# 編輯說明

- 一、本問題與答覆彙編係原能會專案小組審查台電公司龍門計畫初期安全分析報告書，所提出之問題以及台電公司針對各項問題所做之答覆與說明，為原能會審查結論報告參考附件之一。
- 二、原能會在審查作業期間，共向台電公司提出五百九十八件審查意見，各章審查意見之統計，請參見表一。
- 三、由於資料繁多，為利於參閱，本彙編計分四冊付印，各冊涵蓋章別，請參見表二。
- 四、各冊內容均概分為「審查意見摘要表」及「審查問題與答覆內容」兩大部份，謹供對照查閱。

# RESPONSES TO ROC-AEC's PSAR QUESTIONS

PSAR Sections: 4.3.2.1 Shutdown Reactivity

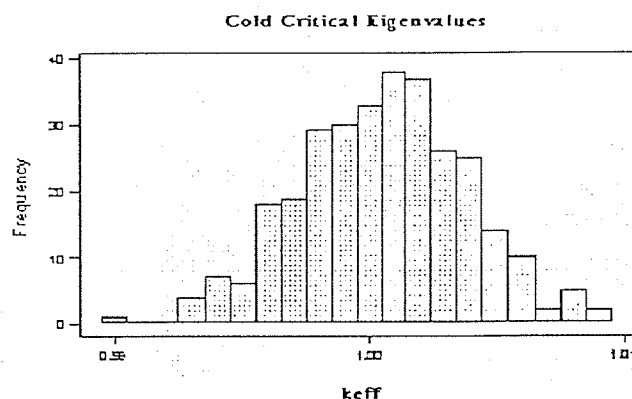
Change asterisk \* footnote to read “For the core loading in Figure 4.3-1, Critical  $k_{\text{eff}} = 0.995$ .”
